Dockyard and Engineering Works Ltd
Bangladesh Navy
Sonakanda, Narayanganj

06.02.6758.165.07.193.25.2702

AMENDMENT OF TECHNICAL SPECIFICATION

A. DEW Ltd Tender no: 06.02.6758.165.07.193.25.2468 Dated 14 May 2025.

SANITARY DISCHARGE SYSTEM

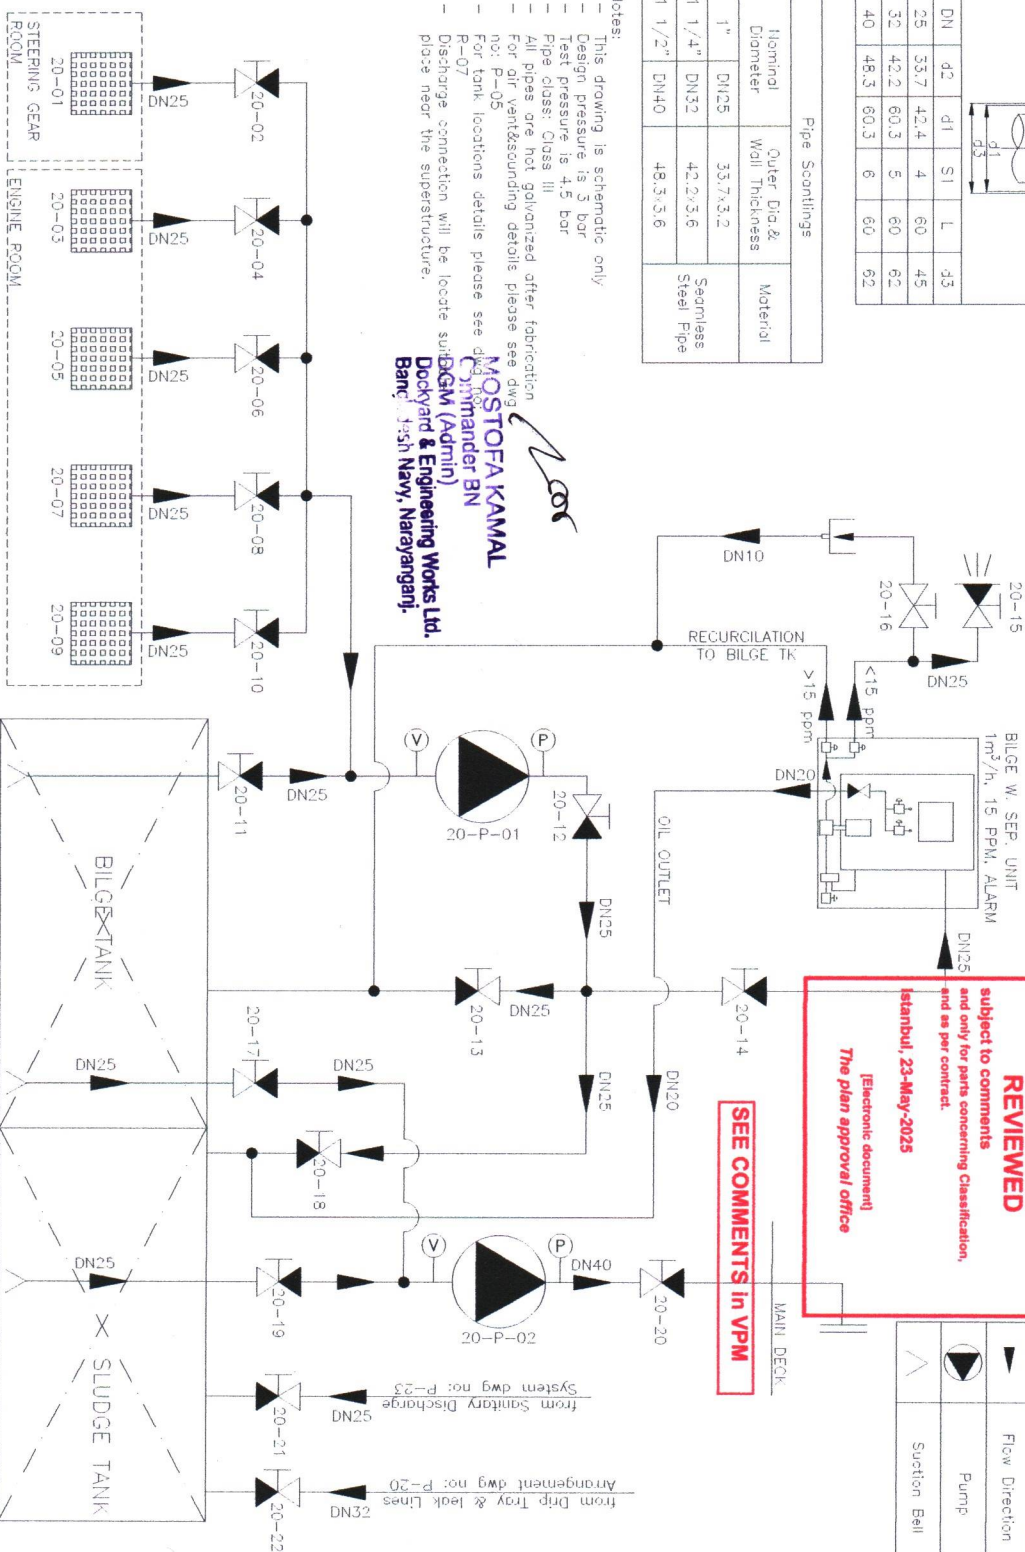
Clause No	For	Read	Remarks
Technical Specification Annex B of serial no: 10	Special (Set On) Flange (Galvanized) Pressure rating: PN 6 Size/ Dimension: DN 50	Special (Set On) Flange (Galvanized) Pressure rating: PN 10 Size/ Dimension: DN 40	
Technical Specification Annex B of serial no: 11	Special (Set On) Flange (Galvanized) Pressure rating: PN 6	Special (Set On) Flange (Galvanized) Pressure rating: PN 10	
Technical Specification Annex B of serial no: 12	Special (Set On) Flange (Galvanized) Pressure rating: PN 6	Special (Set On) Flange (Galvanized) Pressure rating: PN 10	
Technical Specification Annex B of serial no: 13	Special (Set On) Flange (Galvanized) Size/ Dimension: DN 15	Special (Set On) Flange (Galvanized) Size/ Dimension: DN 25	
Technical Specification Annex B of serial no: 32	MARPOL Flange Size/ Dimension: DN 50 Quantity: 5 Nos	MARPOL Flange a. Size/ Dimension: DN 50 Quantity: 3 Nos b. Size/ Dimension: DN 40 Quantity: 2 Nos	Drawing attached
